Subject: Duke Energy Corporation  
Oconee Nuclear Station - Units 1, 2, and 3  
Docket Nos. 50-269, 50-270, and 50-287

Revisions to Topical Report DPC-NE-3003 In Support of  
Steam Generator Replacement  
Response to NRC Staff Request for Additional  
Information

Enclosed herein, please find the Duke Energy Corporation (Duke) response to the May 12, 2003 NRC staff's request for additional information concerning topical report DPC-NE-3003, Revision 1, "Mass and Energy Release and Containment Response Methodology."

### **Duke Power Response To Request For Additional Information**

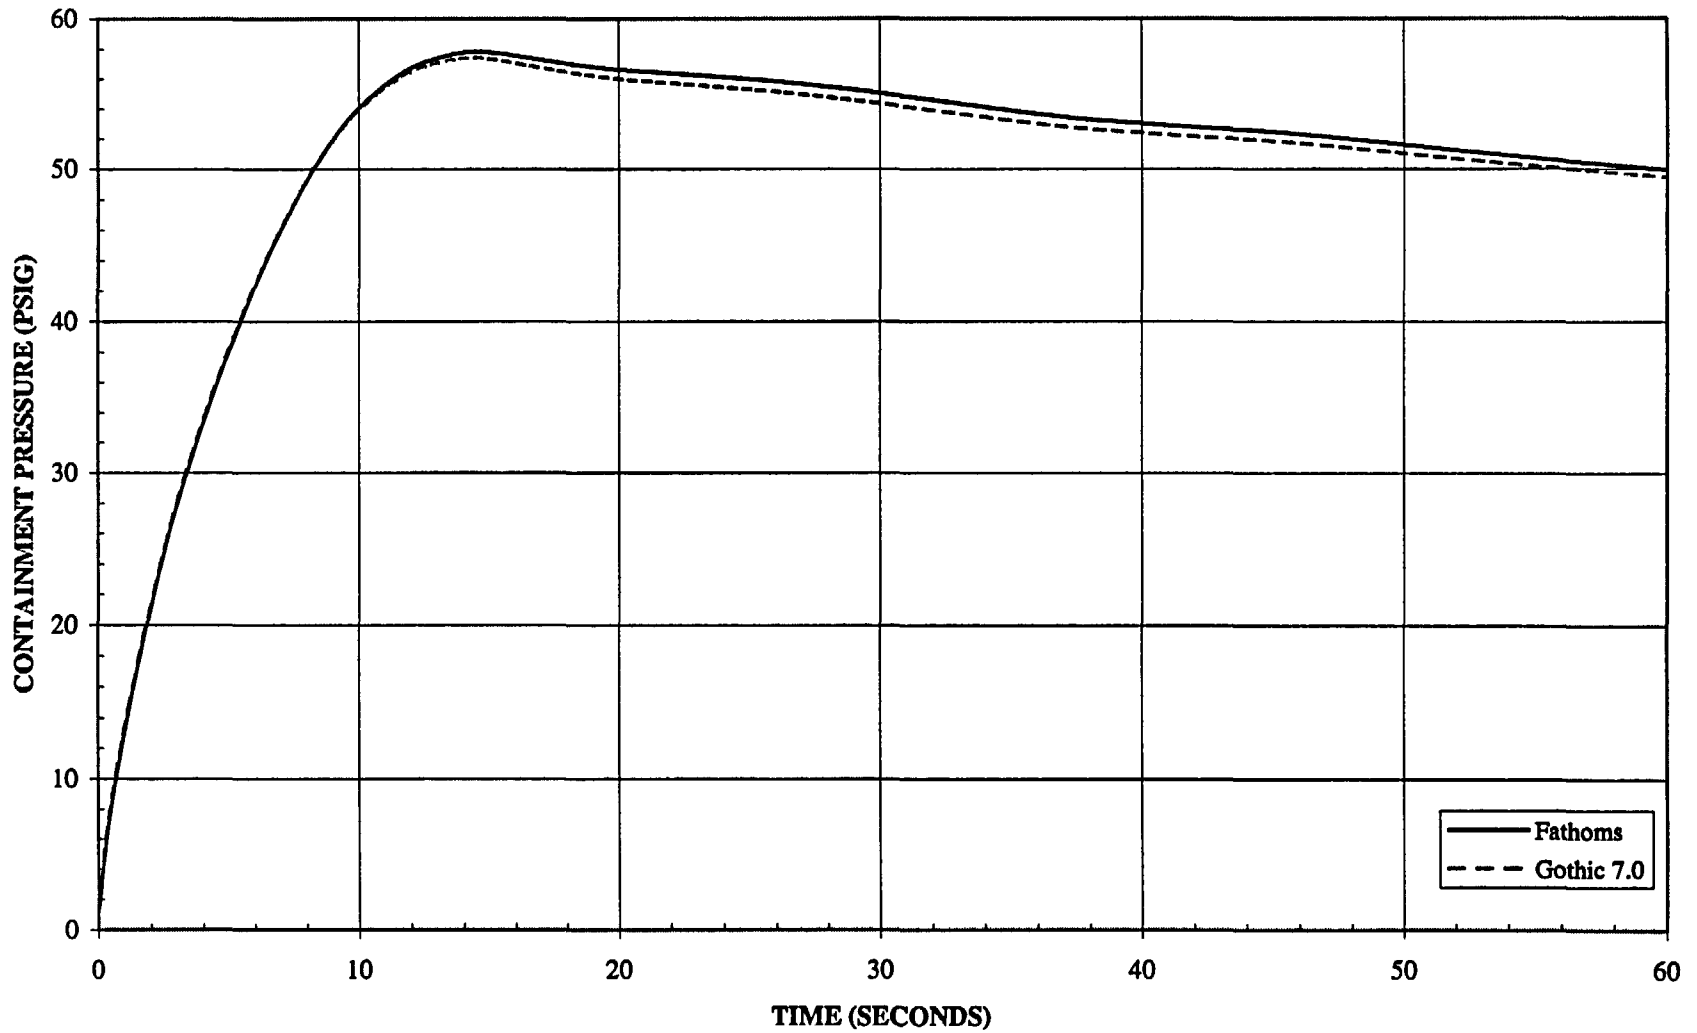
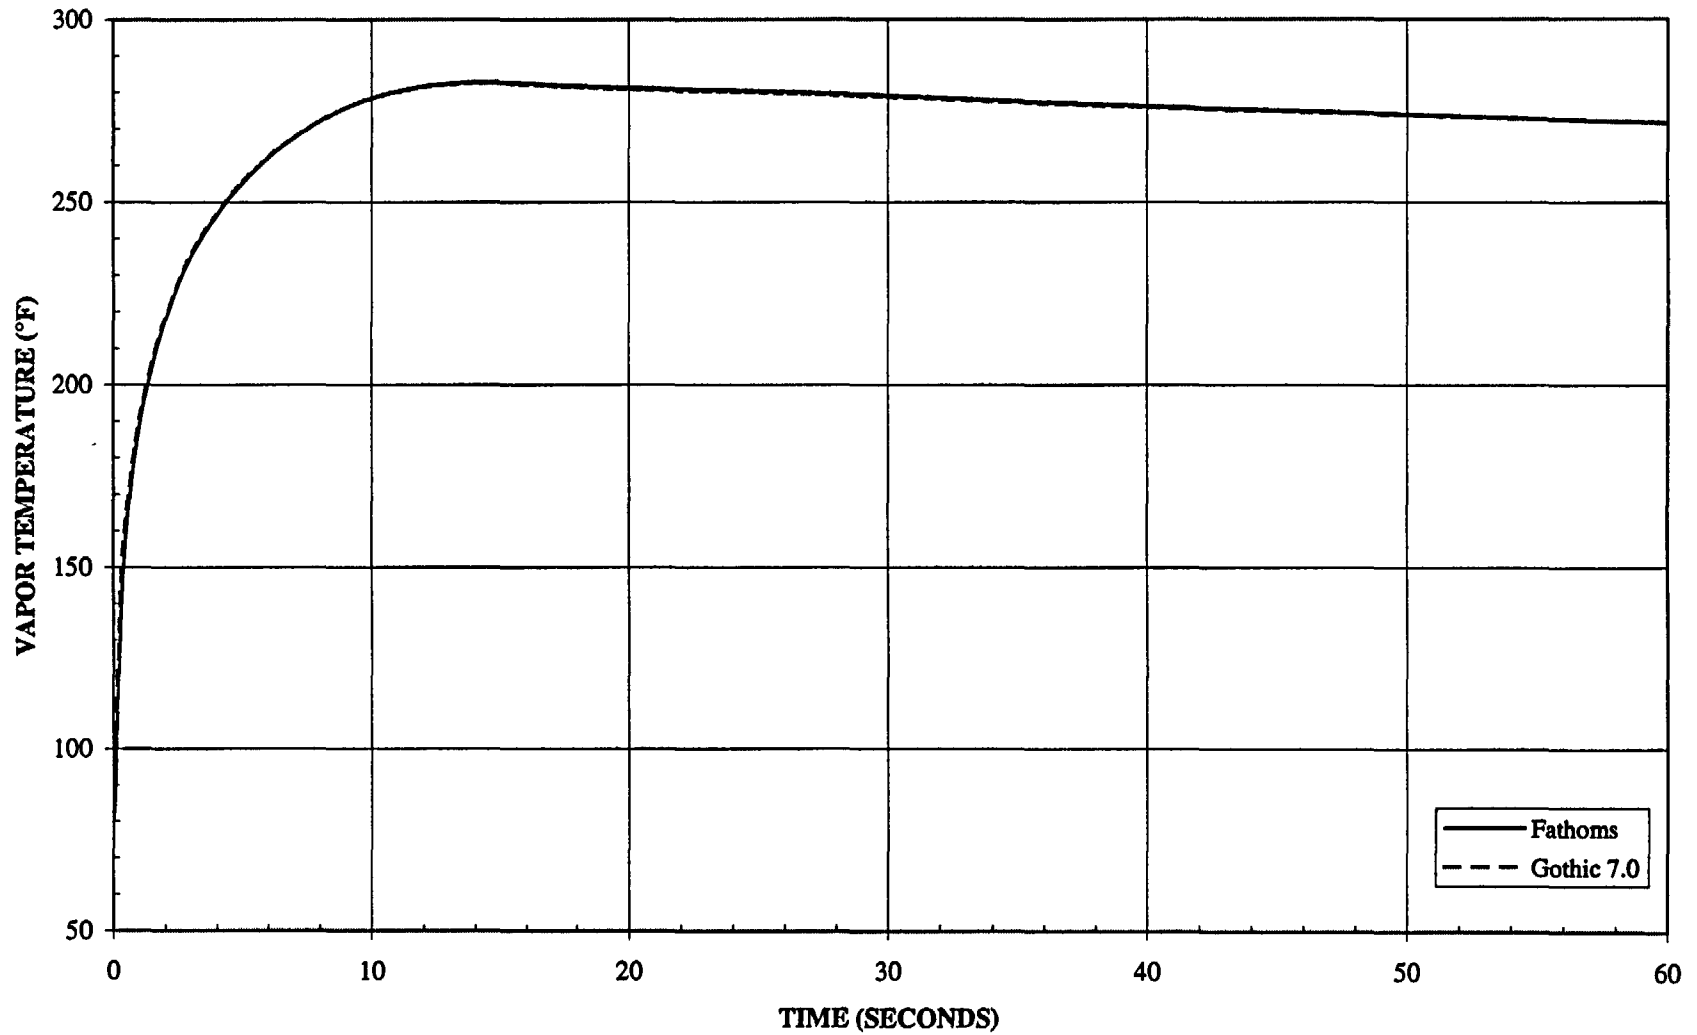
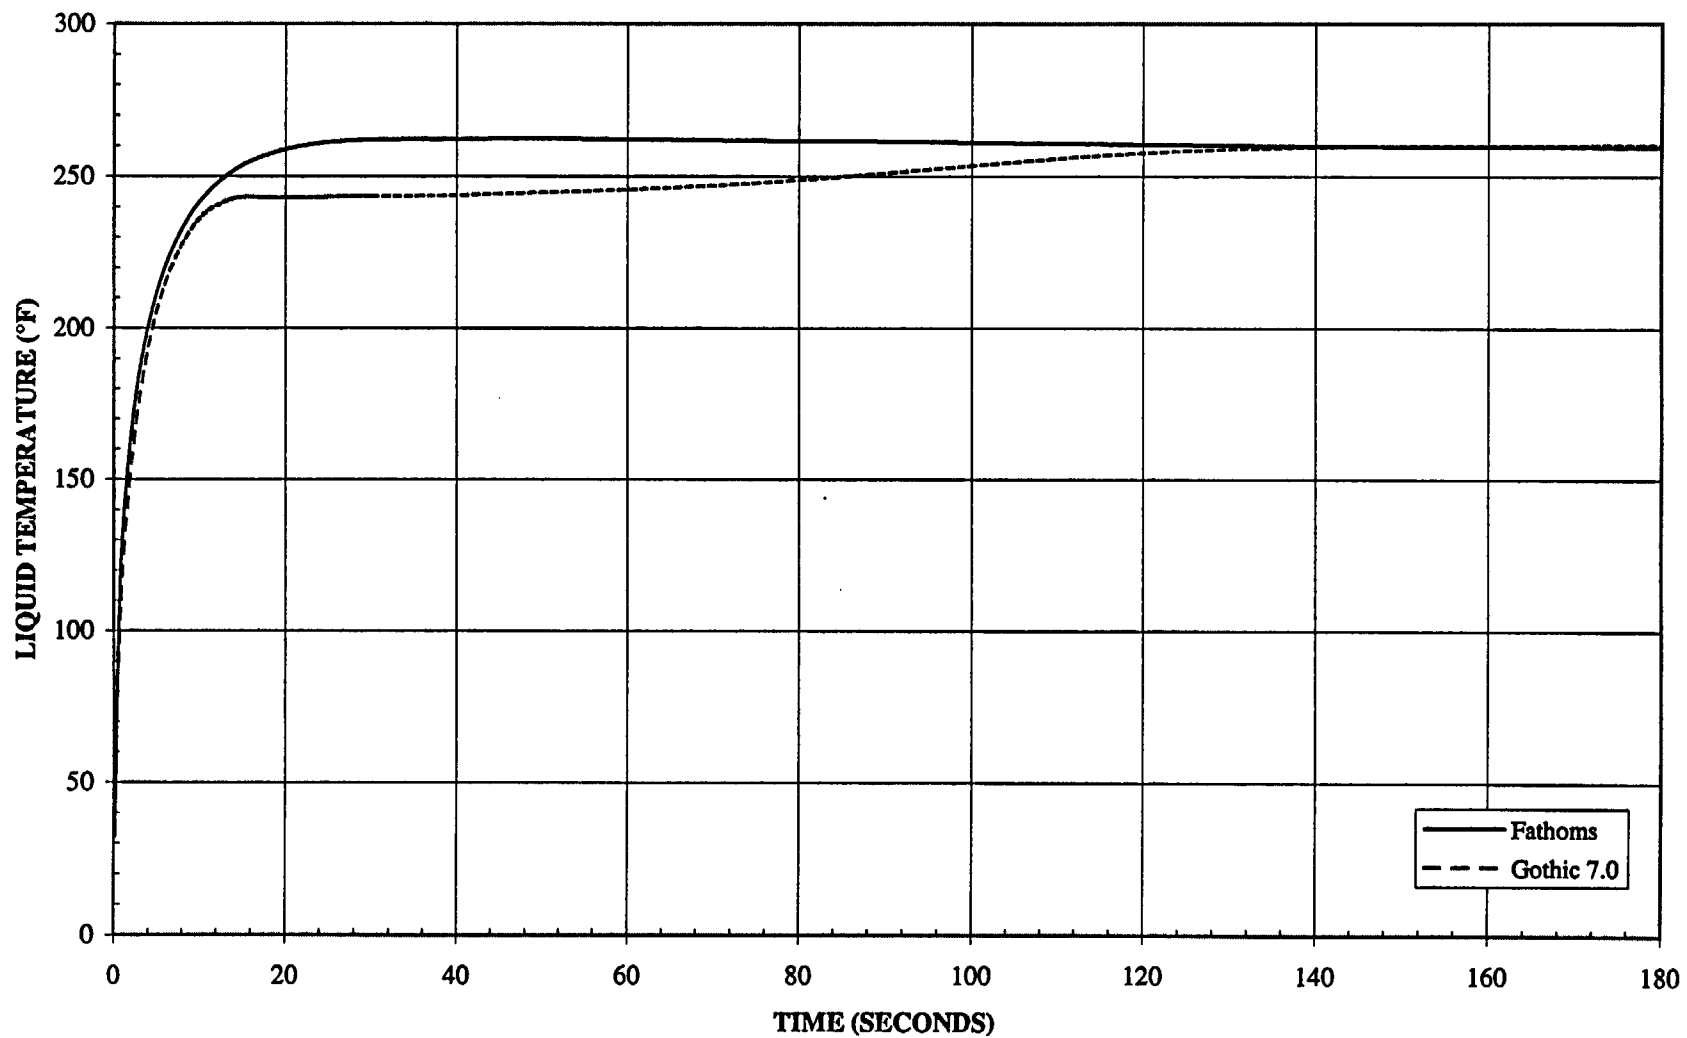
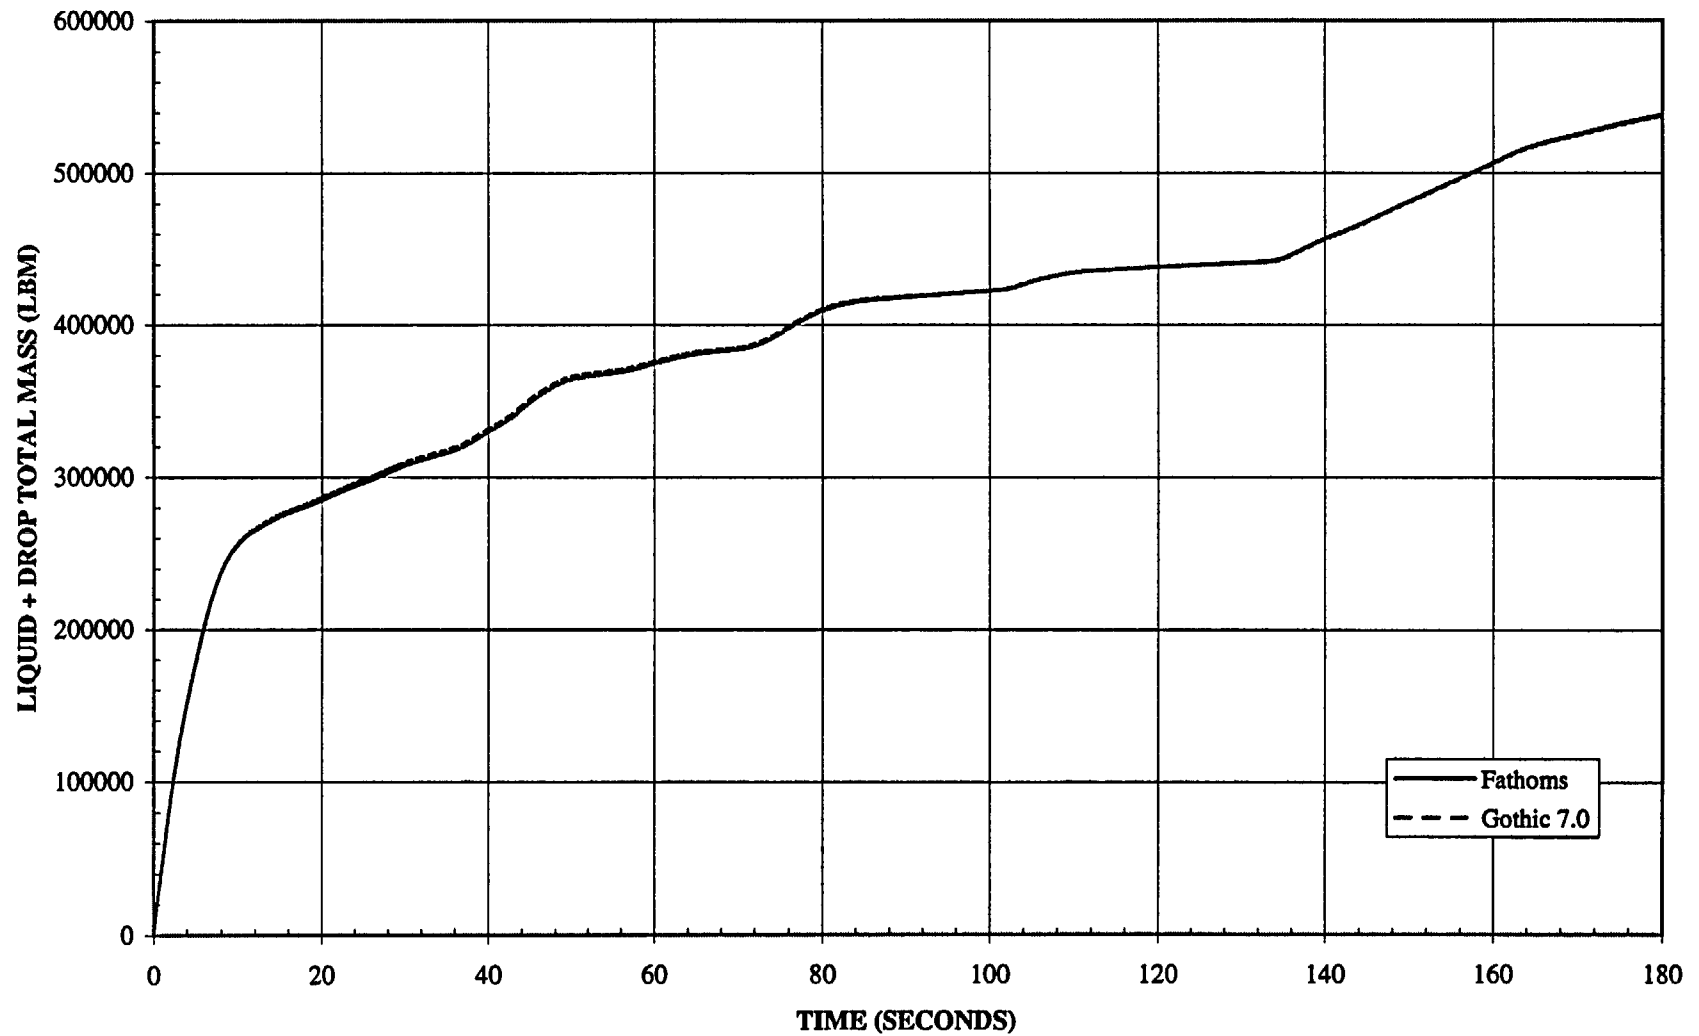
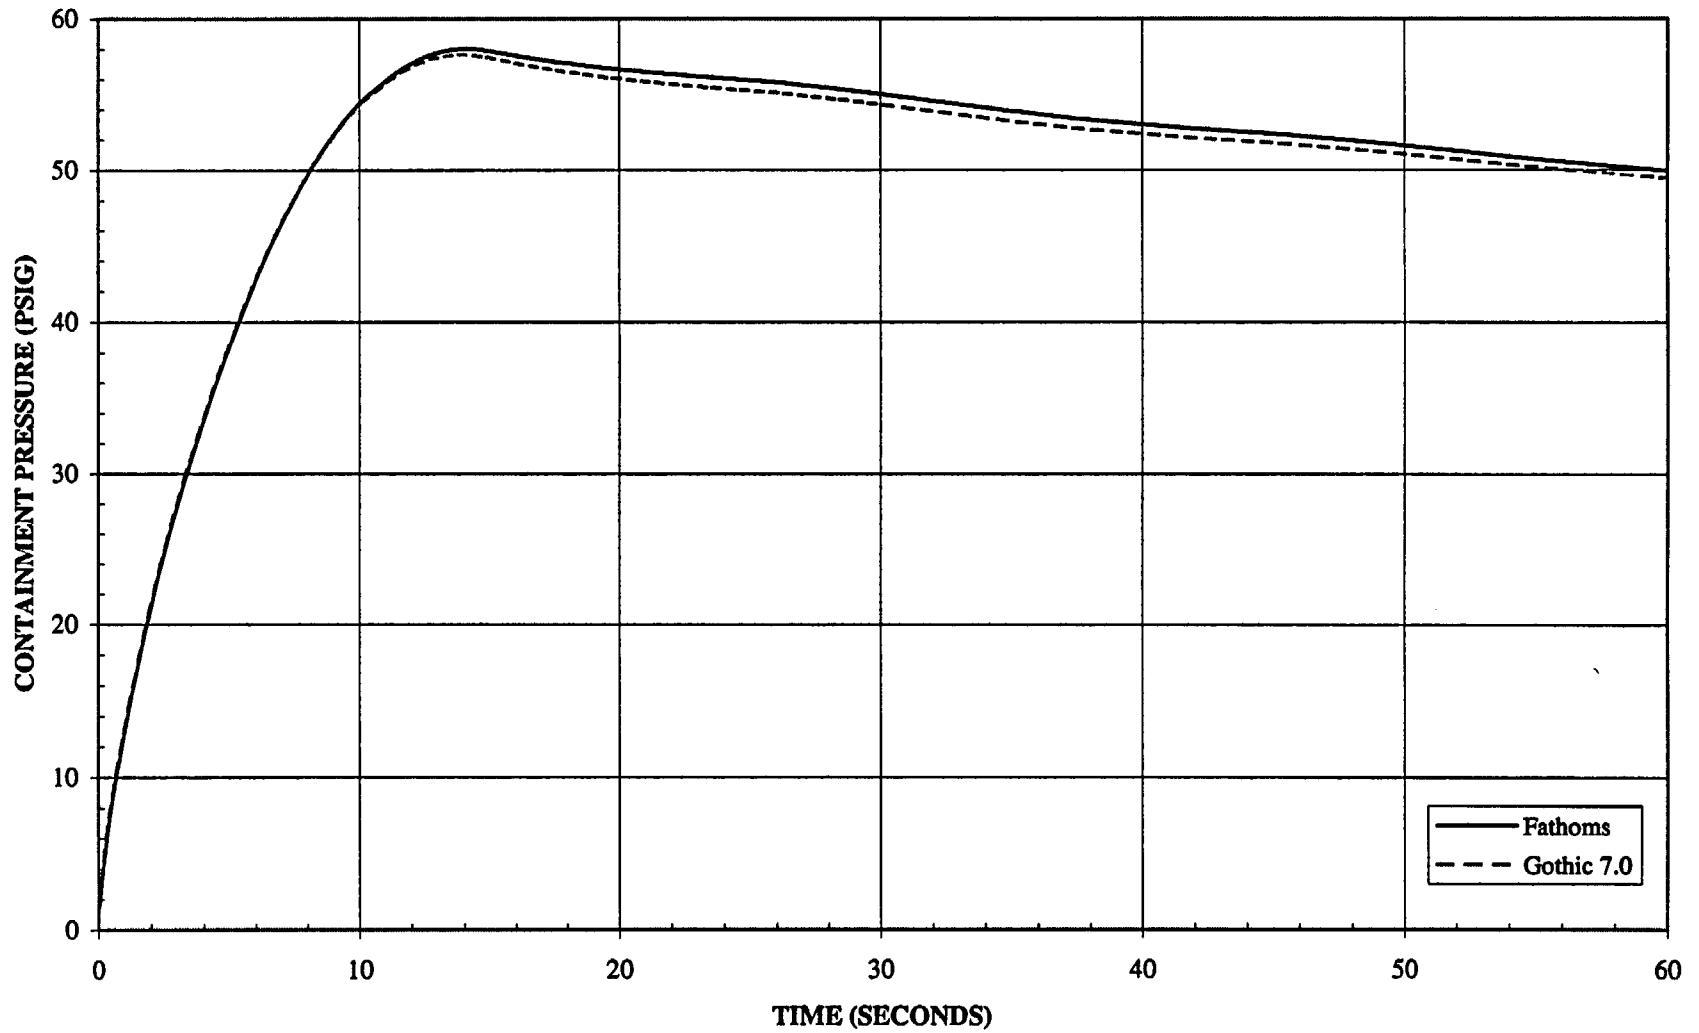
3. Please provide the results using the GOTHIC 7.0 code of peak pressure and temperature calculations for the sensitivity cases listed in Table 3.1-1 of DPC-NE-3003 in tabular and graphical form. If the results or conclusions are significantly different from those presented in DPC-NE-3003P, explain the difference.

Response: Table 3.1-1 of DPC-NE-3003 describes a spectrum of LOCA peak pressure cases including a range of break locations and sensitivity analyses for several important modeling assumptions. The staff's request is understood to focus on the difference in the predicted results from the FATHOMS and GOTHIC 7.0 code versions. Rather than show the comparison for the cases in Table 3.1-1, a different set of cases has been selected which is more focused on the current knowledge of the key sensitivity parameters. Also, the results presented are for the ROTSGs, which is the subject of Revision 1 to the topical report.

The results of the 14 code comparison analyses are shown in Table 3-1 below and in the figures that follow. In general, the pressure and vapor temperature response predictions were very similar in both magnitude and trend. GOTHIC 7.0 predictions for peak pressures and vapor temperature were slightly lower (~0.5 psig and 0.5°F). These differences are consistent with the code model differences described in the response to Question #1. Both codes predict a saturated containment atmosphere due to the large amount of drops injected. The slightly lower pressure, vapor temperature, and liquid temperature from GOTHIC 7.0 may be attributed to additional drop hold up in the atmosphere. This effectively increases the heat capacity of the atmosphere and reduces the temperature rise for a given energy addition. A comparison of the total liquid and drop masses, and liquid temperatures, show the predictions of the two codes to be essentially the same. This is consistent with the changes in the drop deposition and entrainment models discussed in Question #1. These results show that the two code versions give essentially similar results for the same break location and initial and boundary conditions.
